Access Compliance Report

Public Rights-of-Way

(Curb Ramps)

Intersection ID: 13802	Main Street: LEXINGTON_AV	Cross Street: MYRTLE_AV	Location:	N
ADA ID: AF28BC472290	Ramp Type: Perp	Initial Pass/Fail: Fail	Overall Compliance: No	Severity Score: 26.25

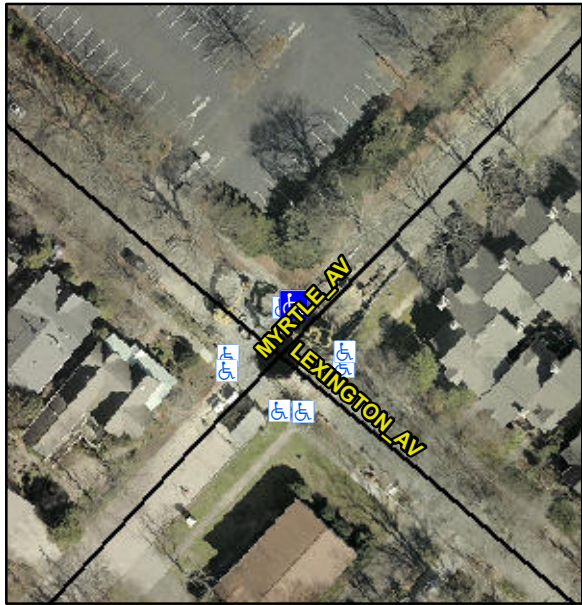
Codes/Mitigation Info/Possible Solution			Field Measurements/Component Compliance					
	Possible Solutions:		Compliance	Description	Data	Compliance	Description	Data
	Remove & Replace Entire Ramp.		N/A	Ramp Length (in)	165.0	No	Ramp Slope (%)	16.0
			Yes	Ramp Width (in)	48.0	No	Ramp XSlope (%)	4.8
			N/A	Flare Type LT	N/A	N/A	Flare Type RT	N/A
			N/A	Flare Slope LT (%)	N/A	N/A	Flare Slope RT (%)	N/A
			N/A	Flare Traversable LT?	N/A	N/A	Flare Traversable RT?	N/A
			N/A	Landing Length (in)	N/A	N/A	DWS Provided?	N/A
			N/A	Landing Width (in)	N/A	N/A	DWS Contrast?	N/A
			N/A	Landing Slope (%)	N/A	N/A	DWS Length (in)	N/A
			N/A	Landing X Slope (%)	N/A	N/A	DWS Full Width?	N/A
Surveyor Notes:			N/A	Landing Curb? (Y/N)	N/A	N/A	DWS Offset (in)	N/A
N/A			N/A	Shared Landing?	N/A			
PROW/ADA:			N/A	Gutter Ponding?	N/A	N/A	Gutter Slope (%)	N/A
Not Found, R304.2.2, R304.5.3			N/A	Gutter Lip Ht (in)	N/A	N/A	Gutter X Slope (%)	N/A

N/A	Painted X Walk1?	No	N/A	Painted X Walk2?	N/A
				X Walk 1 Direction	To SE		X Walk 2 Direction	N/A
			N/A	X Walk 1 Width (in)	N/A	N/A	X Walk 2 Width (in)	N/A
				X Walk 1 Slope (%)	3.4		X Walk 2 Slope (%)	N/A
				X Walk 1 X Slope (%)	1.7		X Walk 2 X Slope (%)	N/A
			N/A	Ramp inside XWalk1?	N/A	N/A	Ramp inside XWalk2?	N/A
				Road Slope (%)	N/A	N/A	Clear Space?	N/A
				Road X Slope (%)	N/A	N/A	Clear Space to XWalk (in)	N/A
			N/A	Any Obstructions?	N/A	N/A	Storm Grate/Utility Hazard?	N/A
				Obstruction Type			Storm Grate/Utility Type	
						N/A		N/A
						Yes	Surface Condition? (G/P)	Good
